Access Compliance Report

Public Rights-of-Way

(Curb Ramps)

Intersection ID: 52118	Main Street: REAMES_RD	Cross Street: LONGVIEW_CLUB_LN	Location:	N
ADA ID: F5EF3F35A24E	Ramp Type: Perp	Initial Pass/Fail: Pass	Overall Compliance: No	Severity Score: 0

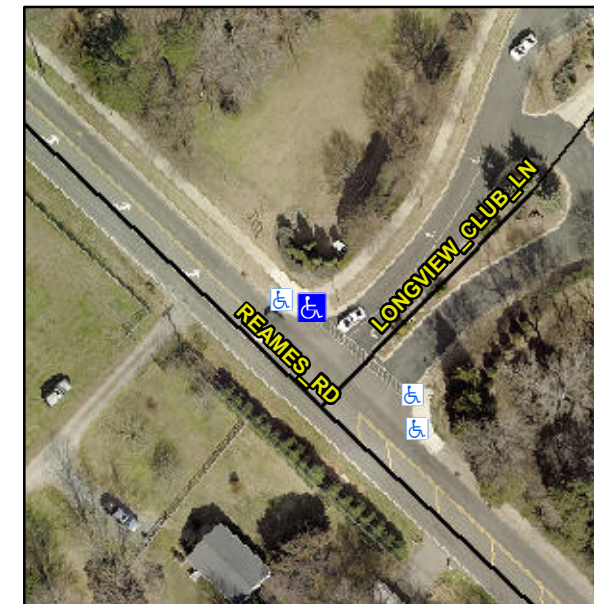
Remove & Replace Detectable Warning System.

R305.2
